Comment Set B1 – Joint Conservation Organizations

Re: Panoche Draft Supplemental EIR
State Clearinghouse No. 2010031008

Re: Response to Draft SEIR for Panoche Valley Solar Project

Figure 1: Snapshot of DSEIR Figure B-3 showing the project site, perimeter roads, and jurisdictional crossings.

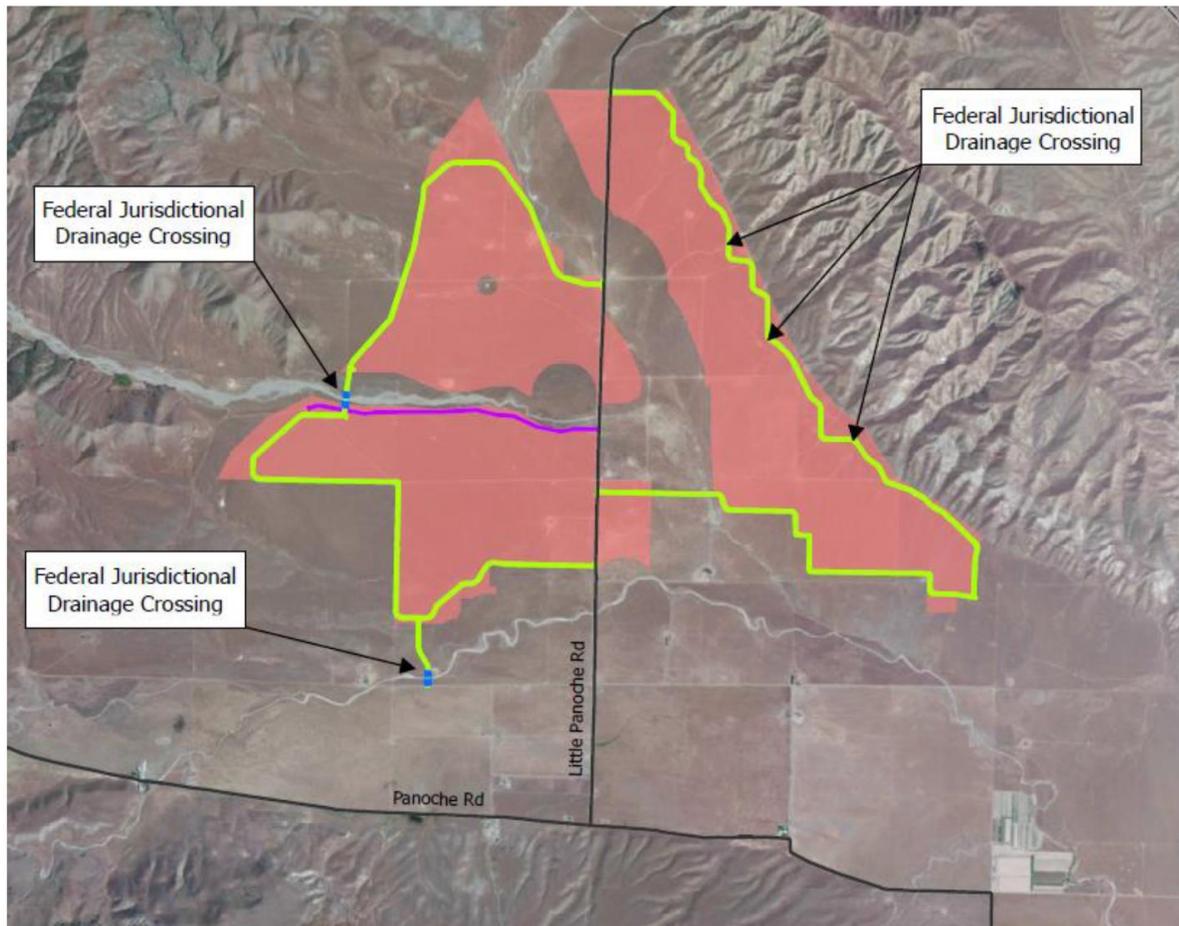
The project site is in the County of San Benito (County) in Panoche Valley (DSEIR, B-1) about 15 miles east of Pinnacles National Park (DSEIR, Figure B-1). The project description does not provide a topographic map or otherwise discuss elevations of the project; this is a drawback to the project description that prevents the reader from obtaining a good overview of the site upon a first reading. The ground surface elevations reported for wells in Geologia (2010a) range from about 1200 to 1350 feet (ft) above mean sea level (amsl). The project area is shown in Figure 1.

Figure 2. Historical depth to groundwater measurements in wells throughout the Panoche Valley.

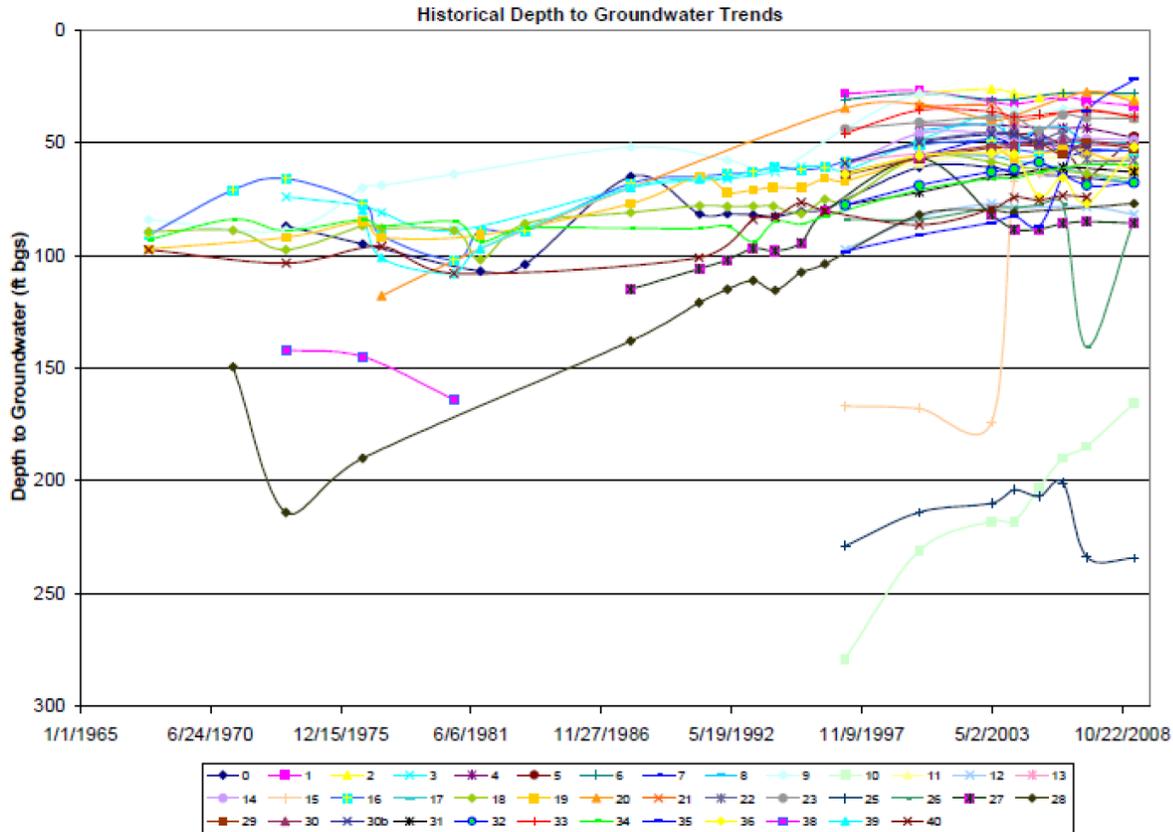
Groundwater levels in most wells in the valley have trended upward since the 1970s by from 10 to 30 ft, with some (well #28) recovering by more than 100 ft (Figure 2). Most had been steady from the late 1990s through 2008 (Id.). Two deeper wells (well #s 10 and 25) have water levels

Figure 3: Snapshot of a portion of Figure 1 (Matthews and Haizlip 2014b) showing water surface contours and individual well levels.

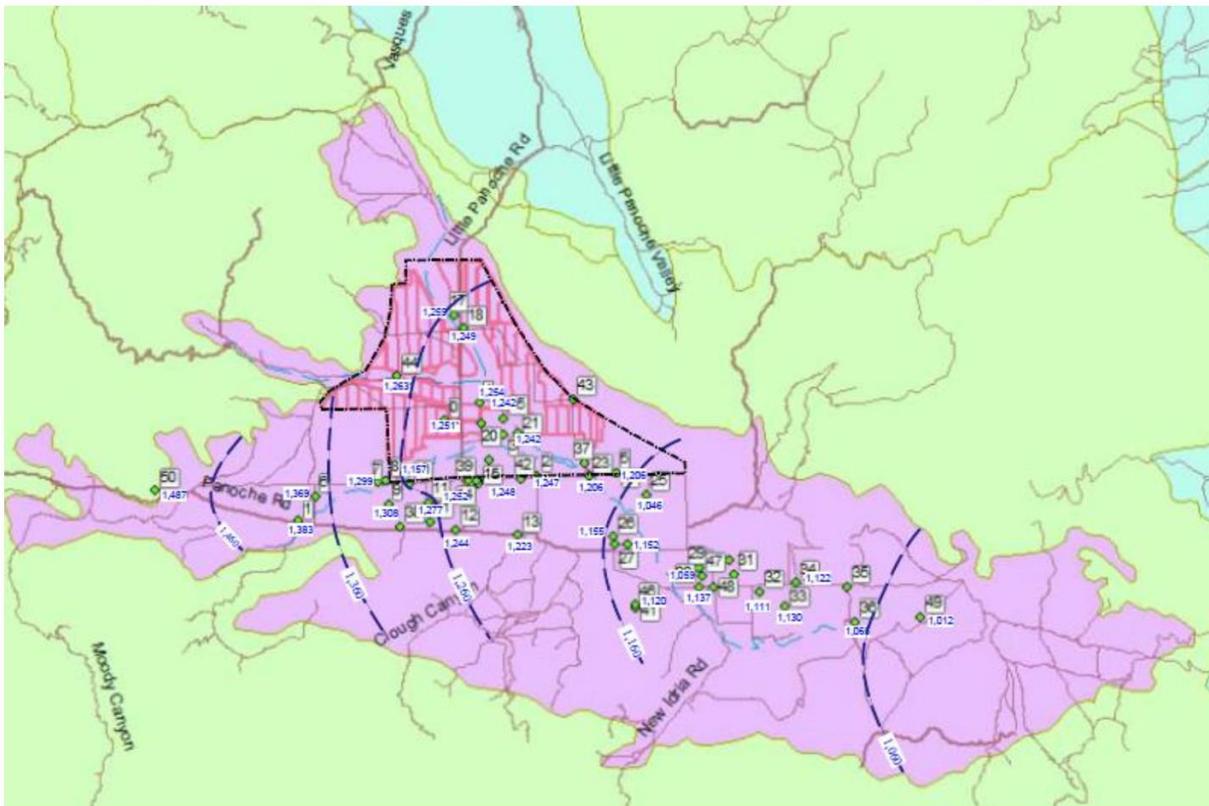
The groundwater level map in 2014 is highly irregular, regardless of how it was drawn in Matthews and Haizlip (2014b) (Figure 3). The contours show a water table sloping from west to east across the project site, with a steeper slope to the west. There are adjacent wells with more than 150 ft of difference. For example, wells 5 and 25, in the middle at the top, have 1206 and 1046 ft amsl water levels even though the 1060 contour is far to the east. One other well has water surface elevation 1059¹ but it is surrounded by several wells with elevation in excess of 1120 ft. The curve in the 1260 contour just accommodates a well with 1157 ft elevation while being surrounded by many other wells with water levels much higher than 1200 ft. Some of these differences may be explainable by the wells being completed in different levels of the aquifer. If there is a significant difference in water levels among aquifer layers, a contour map should be drawn for different levels to show areas with vertical gradients.

¹ The well number is not visible on Figure 3, but it is in the middle between the 1160 and 1060 contours.

Figure 5: Snapshot of Figure C.6-7 show an Overview of Federal and State Jurisdiction Waters. The red line is project footprint, the light blue surrounded by dark blue is jurisdictional water, the light blue lines are drainage survey lines, and the orange is the project perimeter road.

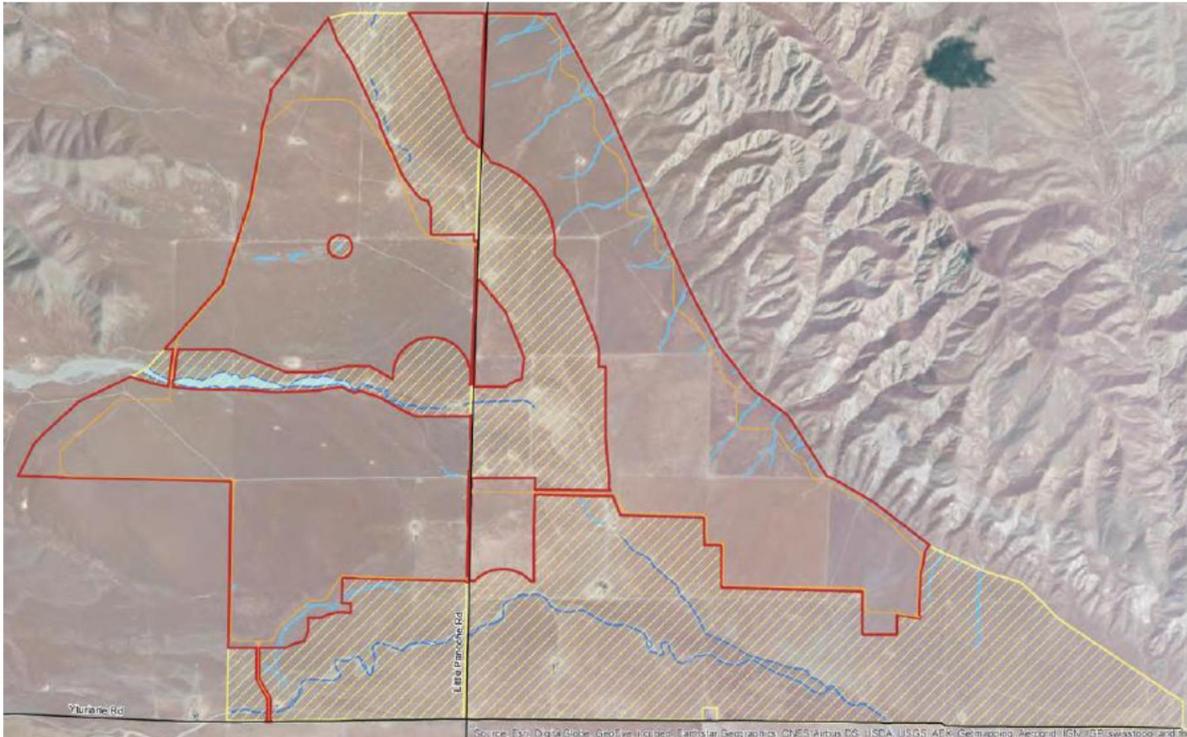
Figure 5 shows the Federal and State Waters Overview (DSEIR, Figure C6-7). The statement in the DSEIR regarding the length of jurisdictional channels is confusing: “The 2010 Final EIR identified approximately 18,700 linear ft of the ephemeral drainage channels within the Panoche Creek drainage, and approximately 7,025 linear ft of Las Aguilas Creek within the project site subject to the jurisdiction of USACE and/or CDFW” (DSEIR, p C6-51). It is not clear whether the 18,700 linear ft is all of the channels in the entire drainage, with Las Aguilas Creek being part of Panoche Creek; a reason to consider Las Aguilas as part of Panoche Creek drainage is that the groundwater basin is considered as the Panoche Creek Groundwater Basin. It is also not clear whether these lengths were jurisdictional, because the following sentence identified “some of the previously identified ephemeral drainages, specifically 5,951 linear ft of such drainages on the eastern side of the Revised Project site have been deemed waters of the U.S. or federal jurisdictional waters” (DSEIR, p C6-52). This sentence implies the 5951 ft were included in the 18,700 ft but also that it is now considered to be jurisdictional.

Figure 5 shows the many drainages emerging from the east side of the valley. As is apparent, the drainages emerge at the top of an alluvial fan. The DSEIR provides no alluvial fan specific analysis considering the complexities inherent with developing the project on an alluvial fan. An alluvial fan is a hydrologically and geomorphically dynamic area, with channels that change location regularly. Such drainages carry a lot of colluvium, or landslide-derived rocks and soils. As the colluvium settles, the drainage fans and channels erode while others fill with sediment. This is a natural process on an alluvial fan and this project, with its road crossings, will significantly alter the natural patterns. There is a great deal of uncertainty in the flow paths, which means that the perceived, or mapped, historical channel or network of channels cannot be relied on to convey the base flood (NRC 1996). This means the area subject to flooding on an alluvial fan is much greater than would be shown on the maps.

Figure 1. Stream crossing location not included in Notification.

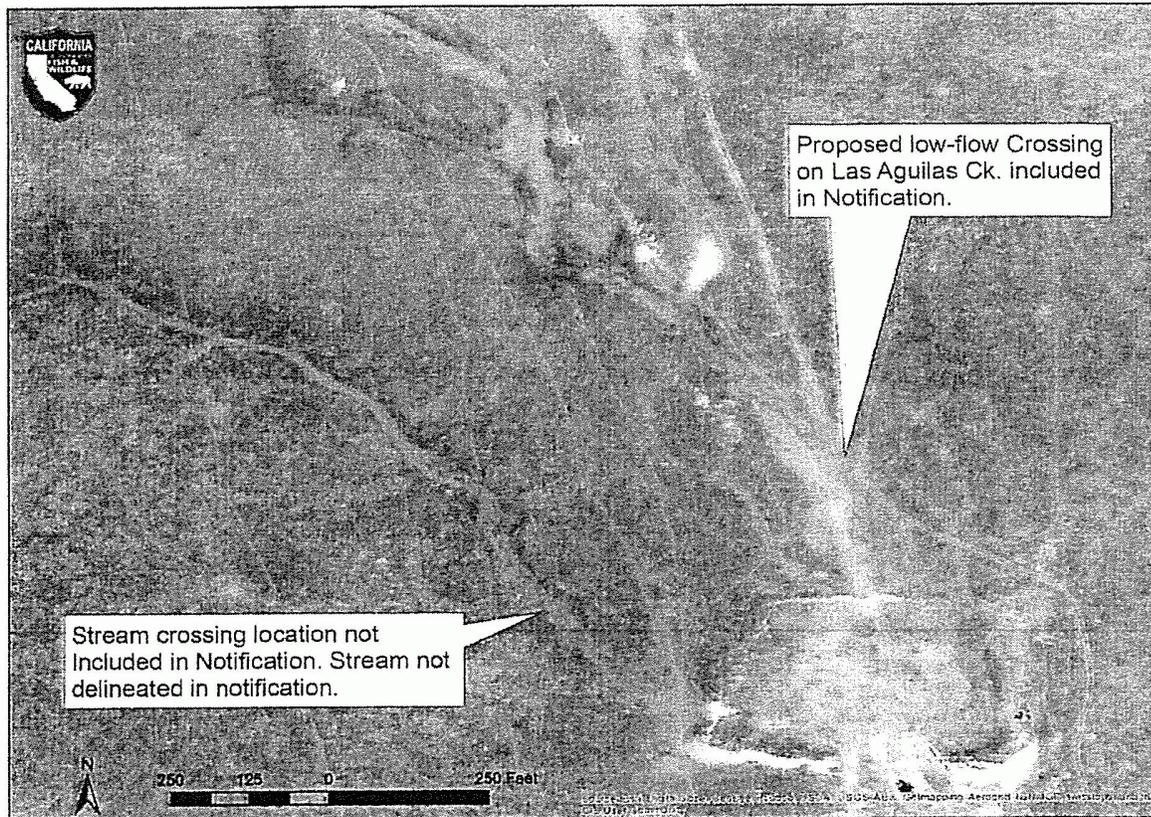
The proposed solar project includes a road that crosses a stream near Las Aguilas Creek, east of Little Panoche Road, but the Notification does not include any information about this stream crossing (see Figure 1 below). Please review this area and include all stream crossings associated with the solar project in any subsequent submittals. The Department requests a site visit to verify the stream delineation.
